## **RECALL 17V-328: E65/E66 (7 SERIES) DOOR LATCHES**

This Service Information bulletin supersedes SI B51 24 17 **dated October 2017**

E65 (7 Series)

E66 (7 Series)

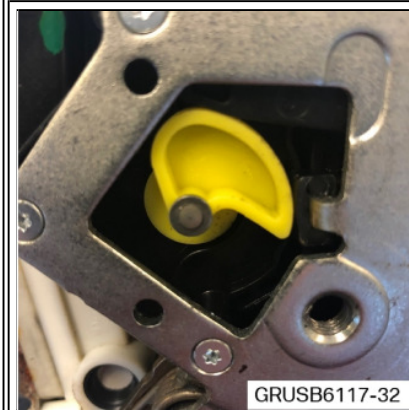
2. Once the door lock is removed, modify each lock by removing the white or yellow opening assist cam (red arrow).

3. Manually position the cam so that it is clearly visible in the opening.

4. Cut the head of the cam retainer off with a pair of cutters.
